Recall Campaign Bulletin

Campaign No. 2023070018, August 2023

SUBJECT: **Model C-Class (206 platform)**
Model Year 2022-2023

Inspect 12V and 48V Ground Connections

Figure 1

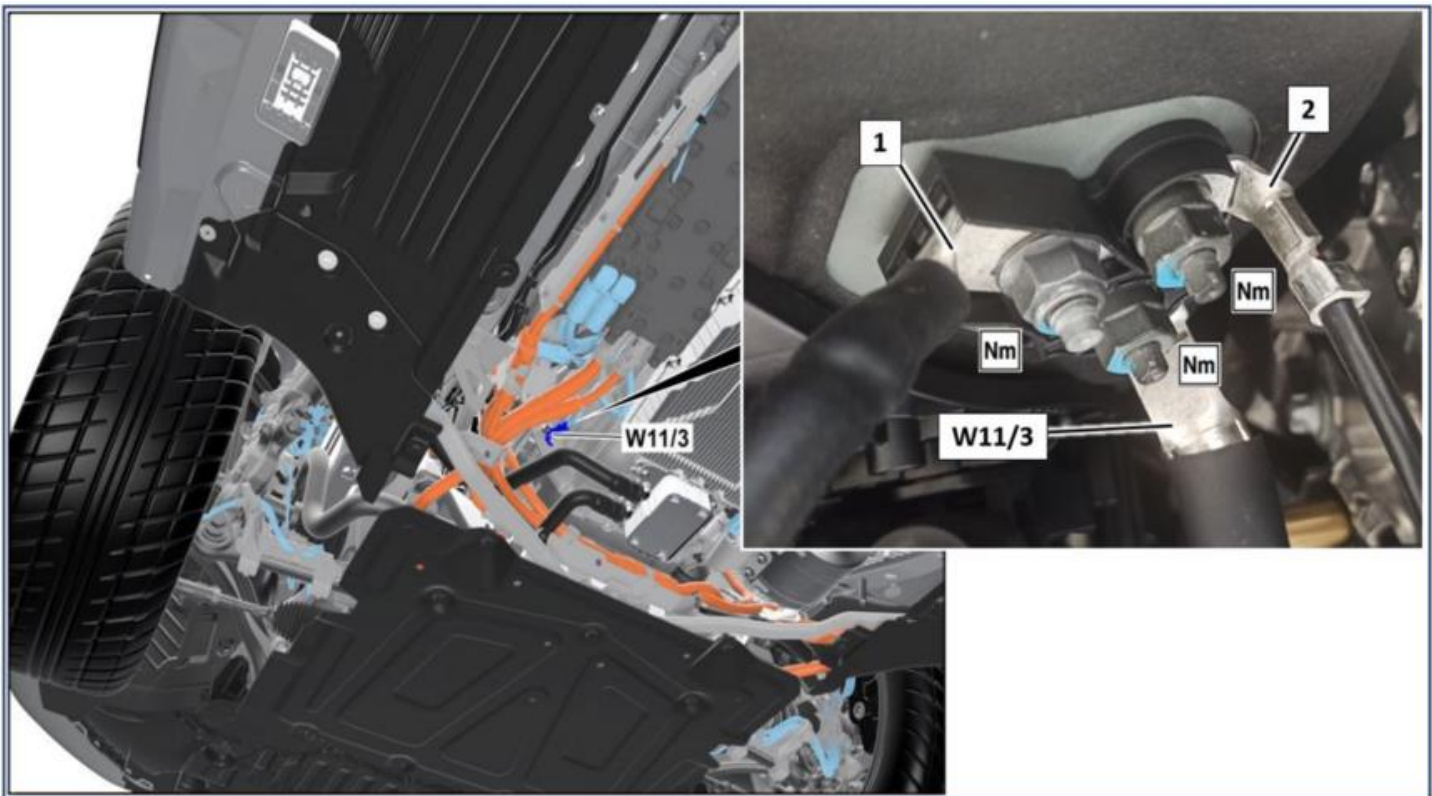
1. Remove rear engine compartment lining.
 - i** For basic information, see AR61.20-P-1105WT.
2. Check whether tightening torque of screw connections on ground points (1, 2, W11/3, Figure 1) is correct.
 - Ground point on left of combustion engine (W11/3, Figure 1) 20 Nm
 - Ground point of terminal 31, with code B01 (2, Figure 1) 20 Nm
 - Ground point of terminal 41, with engine 654 and with code B01 (1, Figure 1) 16 Nm

- a. Torque is **correct**. End measure.
- b. Torque is **not** correct: Carry out **check/Test Procedure 2**.

1. Replace respective nut at ground point (1, 2, or W11/3, Figure 1) and tighten to the specified tightening torque.
 - Ground point on left of combustion engine (W11/3, Figure 1) 20 Nm
 - Ground point of terminal 31, with code B01 (2, Figure 1) 20 Nm
 - Ground point of terminal 41, with engine 654 and with code B01 (1, Figure 1) 16 Nm
2. Assemble in reverse order.

Figure 2, examples of the types of damage to ground points (1, 2, W11/3)

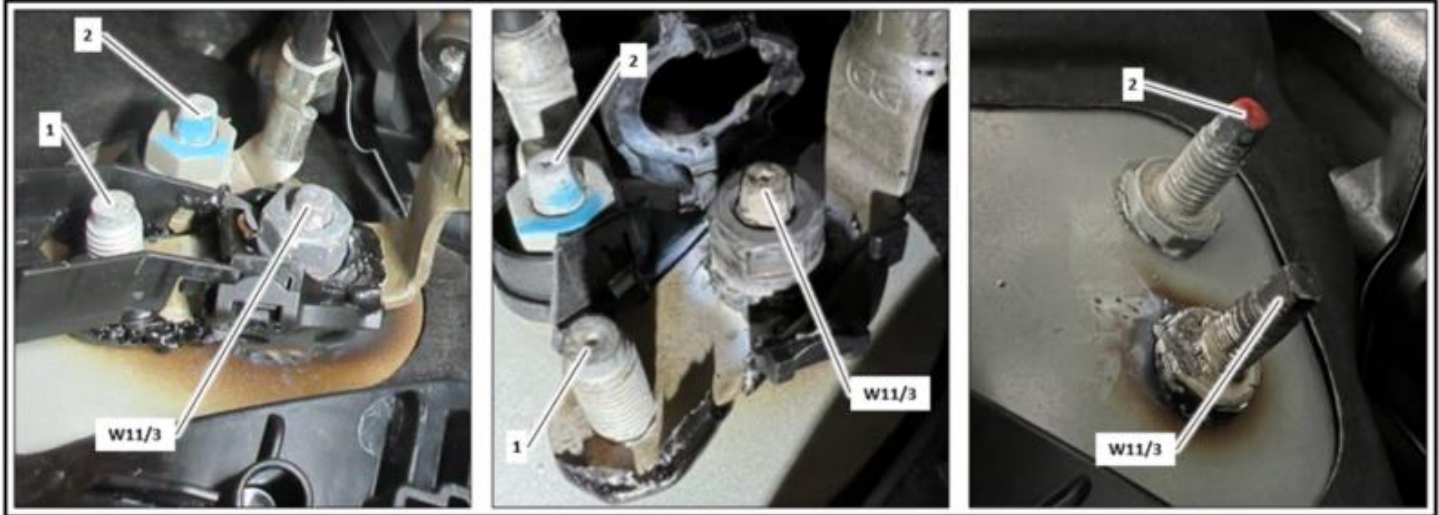
1. Remove respective affected nut at ground point (1, 2, or W11/3, Figure 1) and perform a visual check of the affected electric line, contact area, and weld stud.
 - i** See examples of the types of damage (Figure 2).
 - a. Contact area, weld stud, and electric line **not** damaged: Carry out **Work Procedure 1**.
 - b. Contact area, weld stud, and/or electric line **damaged**: Carry out **Work Procedure 2**.

1. Replace damaged weld stud if necessary.
 - i** For basic information, see AR60.00-P-0100A (part number of weld stud can be found here).
2. If necessary, replace damaged electric line and nut and tighten to the specified tightening torque.
 - Ground point on left of combustion engine (W11/3, Figure 1) 20 Nm
 - Ground point of terminal 31, with code B01 (2, Figure 1) 20 Nm
 - Ground point of terminal 41, with engine 654 and with code B01 (1, Figure 1) 16 Nm
3. Assemble in reverse order.
